Brisbane ARFFS safety review submission

Supplementary visual aids to submission 19

RESPONSE TIME ANALYSIS EXISTING SITE

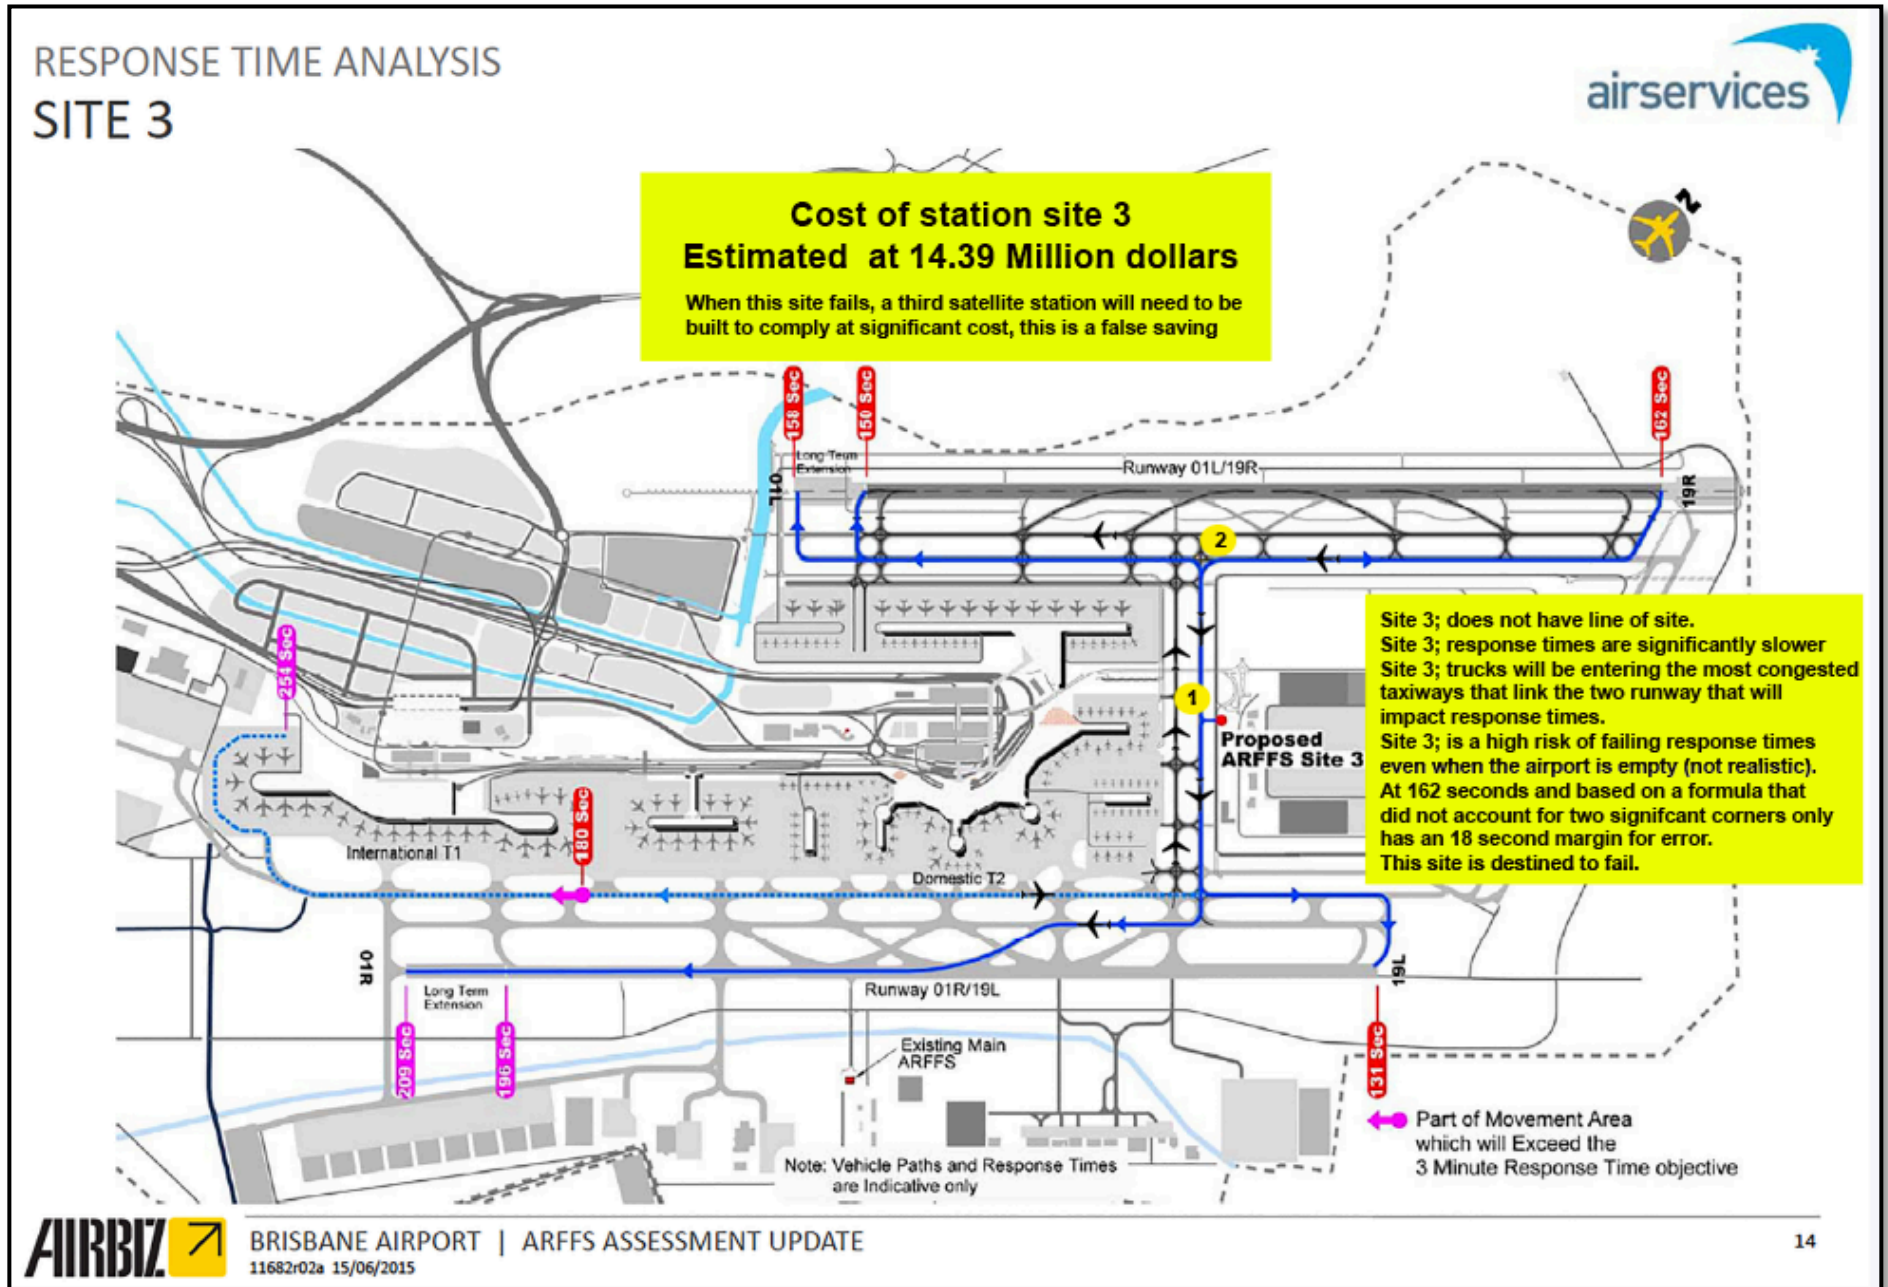
Airservices has selected site 3, operational firefighters do not believe this site meets our regulatory obligations and that site 2 is the only suitable location. It is also obvious by the times, separation distance (2 km) and airport congestion between the runways that they need to be treated separately in regards to resourcing.
